**Before the Commissioners appointed by Canterbury
Regional Council**

IN THE MATTER OF Applications by the Central Plains
Water Trust and Central Plains
Water Ltd. to Take and Use Water
for Irrigation in the Central Plains
area.

Section 42A Officer's Report

Supplementary report of DAVID MICHAEL SCOTT

Figure 1: Alternative representations of hydraulic conductivity.

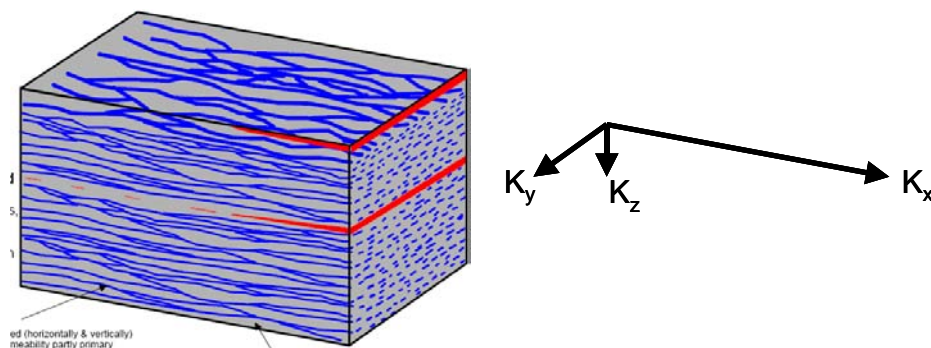
- The other point is a little more complex and made more obscure by my typographic error. My comment should have read “*the aquifer/aquitard layered sequence may simply be a convenient mathematical device to represent the effects **of horizontal** anisotropy on a regional scale*” (correction in bold type). Figure 1 is intended to clarify this point. In modelling groundwater flow in typical sedimentary deposits it is common practice to assume that hydraulic conductivities are isotropic in the horizontal plane (i.e. $K_x = K_y$) but anisotropic vertically (i.e. $K_z \ll K_x$). This configuration of hydraulic conductivity is illustrated in Figure 1a and is easily represented in conventional multi-layer groundwater models. In alluvial-fan systems, such as in the Canterbury Plains, it appears that the configuration illustrated in Figure 1b may be more appropriate to describe the high hydraulic conductivity that can occur within discrete inter-connected flow channels. If this sort of structure is hydrologically significant then representing it with a model that ignores that characteristic may result in physically unrealistic parameter values.

Figure 2: Simulated piezometric level at well L36/0092 for Base Case (without CPW) and CPWES scenarios.

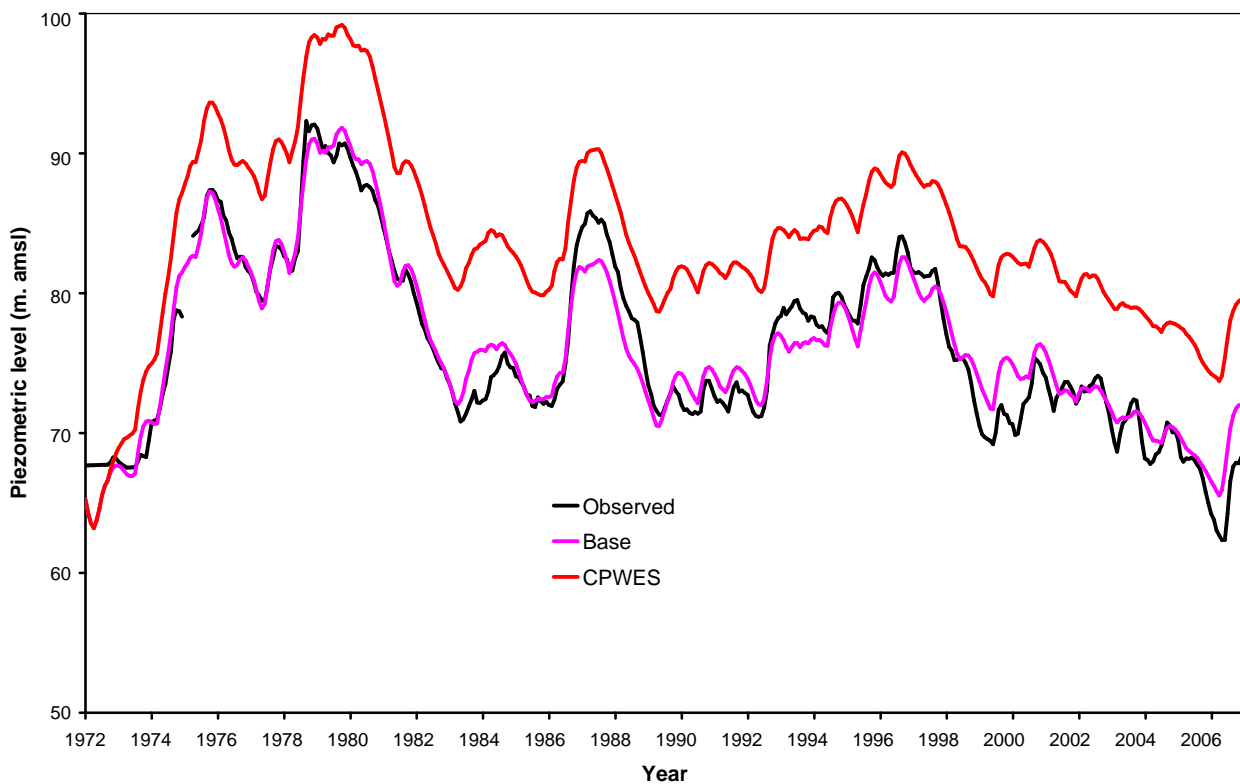
- the area commanded by the CPW scheme occupies the inland 50% of the model domain
 - 60% of that area is supplied by the scheme³.
9. Figure 2 provides a comparison of the simulated groundwater levels at well L36/0092 for the case without CPW (Base Case) and for this additional recharge (CPWES). The Base Case is the same result described by Dr Bidwell and the close match to observed levels demonstrates the strong relationship between land surface recharge and groundwater levels. The CPWES scenario suggests that a new dynamic equilibrium develops over 6 to 8 years with groundwater levels elevated by approximately 8 metres compared to the Base Case. These figures are similar to some of the results described by Mr Weir. The critical difference is that the Eigenmodel shows that, with the CPW scheme in operation, groundwater levels at well L36/0092 would likely be 8 metres higher than the observed levels – not 5 metres lower as predicted by Mr Weir⁴. This suggests that the model may be under-estimating groundwater level by about 13 metres at that particular location.

10. I should acknowledge that this analysis has been done on the assumption that the additional recharge resulting from irrigation is the same from one year to the next. This has been done to simplify the analysis but it is a reasonable approach given that demand for irrigation water is not particularly dependent on the prior winter recharge as demonstrated by Dr Bright's estimates of seasonal water use. Figure 5 in Dr Bright's evidence shows high demand for the year ending 31 May 1978 despite that being in a period with higher than average dryland recharge **and** groundwater levels.

Figure 3: Simulated groundwater levels for well M35/1000 in relation to an assumed critical level.

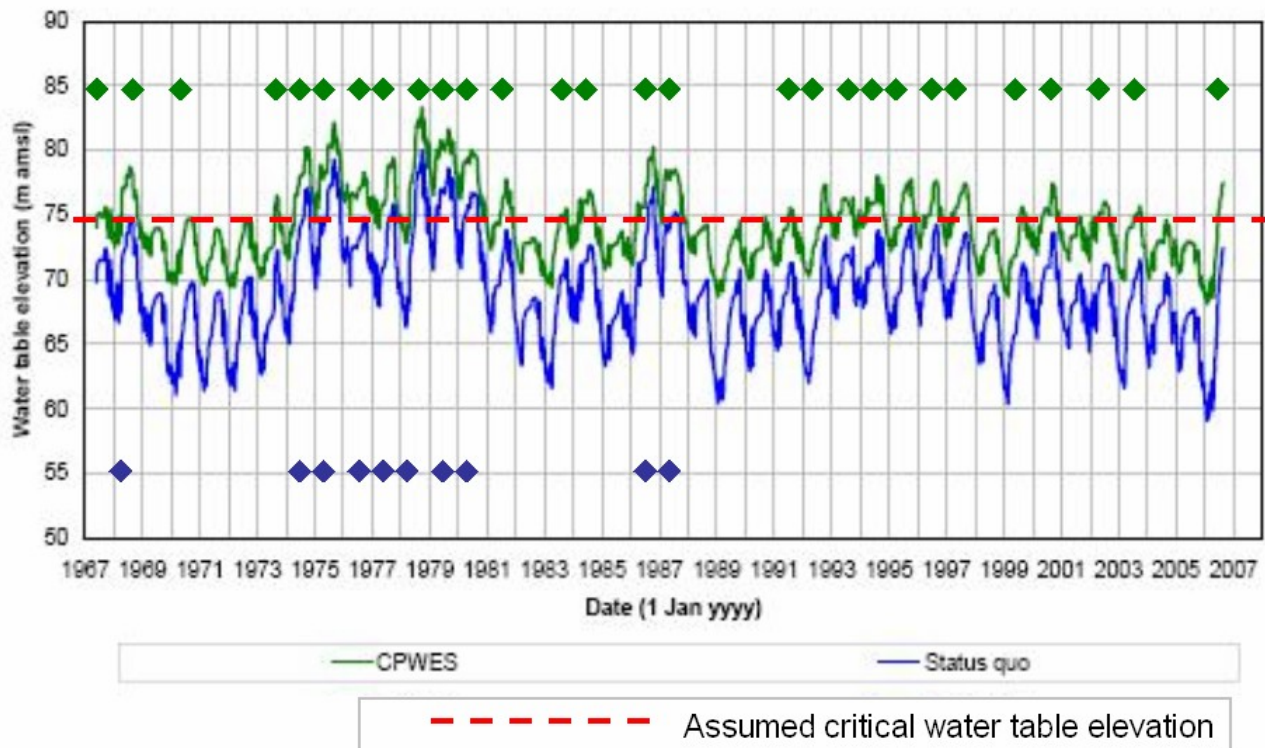
12. In para. 49 of his response Mr Weir agrees with my comment that it will be difficult in the future to clearly distinguish CPW scheme induced effects from climate driven ones but then goes on to misconstrue the point I was attempting to make – i.e. significant CPW scheme effects may be masked by climate. In my opinion this is a very important issue and I would like to illustrate my point by referring to the simulated groundwater levels for well M35/1000 shown in Figure 3 which has been adapted from Mr Weir’s evidence (Appendix E). Let us assume, by way of example, that a hypothetical farmer’s ability to cultivate and/or harvest crops would be

compromised in years when shallow groundwater levels rose above 75 metres (depicted by the dashed red line). For the Status Quo case that critical condition would have occurred in 10 of the 40 years simulated (indicated by the blue diamonds). For the CPWES scenario the critical condition would occur in 28 of the 40 years – an almost three-fold increase which would be likely to have a significant effect. Nevertheless, despite this increased frequency being caused by the CPW scheme, it would be very difficult for the affected farmer to demonstrate that the adverse effects are as a direct consequence of the scheme. Mr Callander, in para 4.10 of his evidence for Christchurch City Council, makes the same point and I agree with his opinion that it would be unreasonable to place the burden of proof on the affected party.
